EPA (Environmental Protection Agency)
Evaluation of the P.A.S.S. KIT
Device under Section 511 of the Motor
Vehicle Information and Cost Savings Act

EPA-AA-TEB-511-82-14

September, 1982

Test and Evaluation Branch
Emission Control Technology Divison
Office of Mobile Sources
U.S. Environmental Protection Agency

ATTACHMENT A

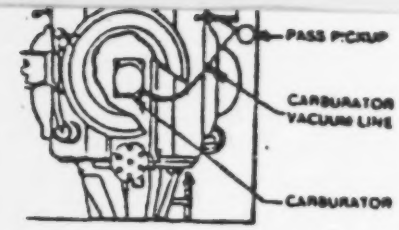
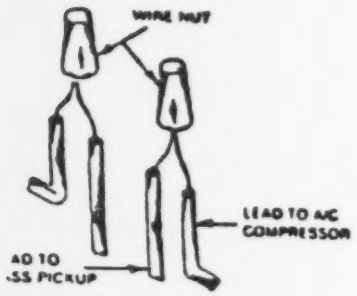
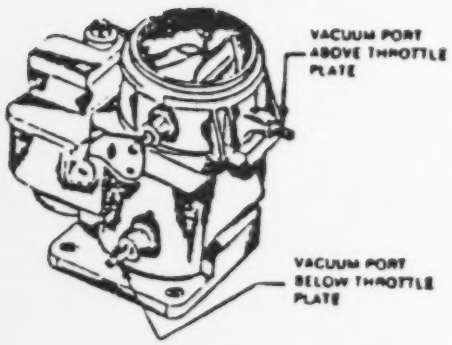
* EPA NOTE: The installer may encounter moderate difficulty in locating the proper vacuum line. Vacuum port elevation/location is not always indicative of the type of vacuum signal. Also, some Fords have dual advance (two vacuum lines).

Exhibit A, installation instructions, shows that the off set-point is adjustable. Although you do provide instructions for making this adjustment, you provide no guidance on how to determine the most desireable set point for the user's specific vehicle and driving conditions. The installation instructions should either describe such a procedure or include a list of settings for specific vehicles and driving conditions. Please send us any information on adjustment procedures or recommended settings.

Set red dot on adjusting screw (found under removable rubber cover) to line up with the 4,6, or 8 cylinder setting position shown on the body of the switch. Locate a suitable existing mounting bolt, or drill a 1/8" hole and mount the unit with the sheet metal screw provided. Mount switch to allow screwdriver access to adjustment screw.

You have now completed the installation of your P.A.S.S. KIT. However, if you wish, additional "fine tuning" can be accomplished as follows:

1. Remove black protective cap.
2. To have compressor clutch cut out earlier, turn screw clockwise one/tenth turn at a time.
3. To have compressor clutch cut out later, turn screw counter clockwise one/tenth turn at a time.
4. Replace black protective cap. (The black protective cap must be replaced.)

The above described fine adjustment is easily accomplished if you can hear or "feel" your A/C disengage. If not - we suggest that you temporarily run a wire from the P.A.S.S. KIT switch into the passenger compartment. Connect to a 12 volt bulb or circuit tester and run wire back to the A/C clutch lead. When bulb is lit, A/C clutch is engaged. When bulb is off, A/C clutch is disengaged.
